Access Compliance Report

Public Rights-of-Way

Intersection ID: 10019990	Main Street: ARMORY_DR	Cross Street: N/A	Location: NW
ADA ID: F818E4F80280	Ramp Type: PerpDiag	Initial Pass/Fail: Fail	Overall Compliance: No
Severity Score: 13.75			
Codes/Mitigation Info/Possible Solution		Field Measurements/Component Compliance

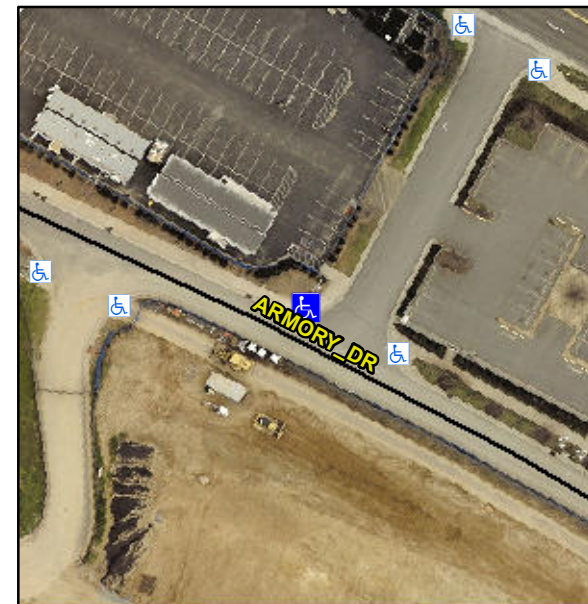
Not Found, R304.2.2, R304.5.3

Compliance	Description	Data	Compliance	Description	Data
N/A	Ramp Length (in)	71.0	No	Ramp Slope (%)	8.8
Yes	Ramp Width (in)	48.0	No	Ramp XSlope (%)	3.9
N/A	Flare Type LT	N/A	N/A	Flare Type RT	N/A
N/A	Flare Slope LT (%)	N/A	N/A	Flare Slope RT (%)	N/A
N/A	Flare Traversable LT?	N/A	N/A	Flare Traversable RT?	N/A
N/A	Landing Length (in)	N/A	N/A	DWS Provided?	N/A
N/A	Landing Width (in)	N/A	N/A	DWS Contrast?	N/A
N/A	Landing Slope (%)	N/A	N/A	DWS Length (in)	N/A
N/A	Landing X Slope (%)	N/A	N/A	DWS Full Width?	N/A
N/A	Landing Curb? (Y/N)	N/A	N/A	DWS Offset (in)	N/A
N/A	Shared Landing?	N/A			
N/A	Gutter Ponding?	N/A	N/A	Gutter Slope (%)	N/A
N/A	Gutter Lip Ht (in)	N/A	N/A	Gutter X Slope (%)	N/A
N/A	Painted X Walk1?	No	N/A	Painted X Walk2?	No
	X Walk 1 Direction	To SW		X Walk 2 Direction	To SE
N/A	X Walk 1 Width (in)	N/A	N/A	X Walk 2 Width (in)	N/A
	X Walk 1 Slope (%)	0.2		X Walk 2 Slope (%)	3.5
	X Walk 1 X Slope (%)	1.9		X Walk 2 X Slope (%)	4.5

Remove & Replace Curb Ramp With Two New Directional Ramps or Equivalent.
